08 03 01 Comment Number 1

The Department of Energy acknowledges the commentor's opposition to new missions at Hanford. Decisions on the storage and disposition of weapons-usable fissile materials will be based upon environmental analyses, technical and economic studies, national policy considerations, and public input.

Storage and Disposition of Weapons-Usable
Fissile Materials Draft PEIS

Figure 2.4-4. Conceptual Facility Location for the Disposition of Plutonium at Panhandle, Texas

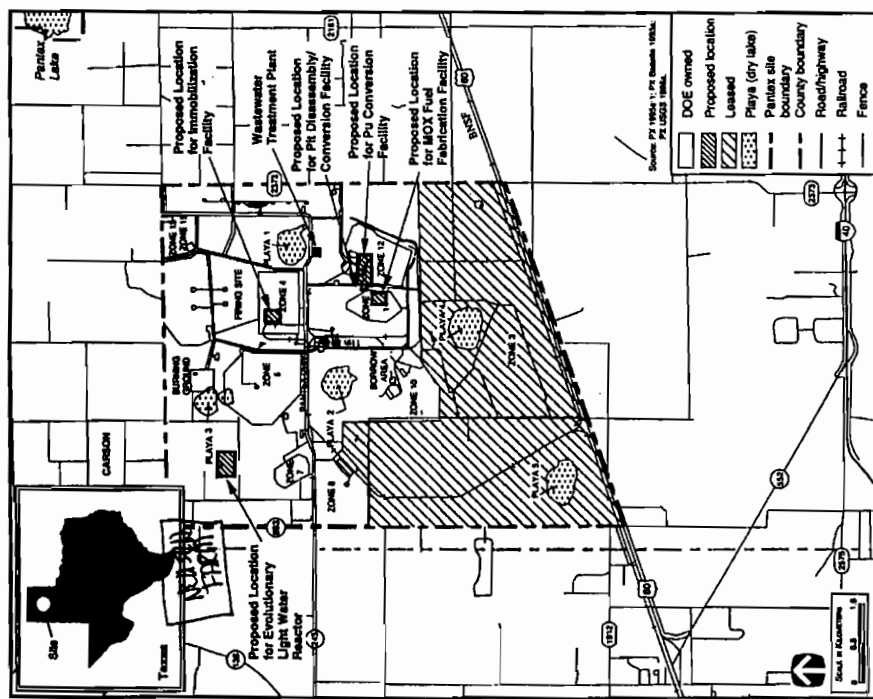
Thank you, 335-9723
Mike W. Black, DOE 2 BOX
PANHANDLE TX
10068
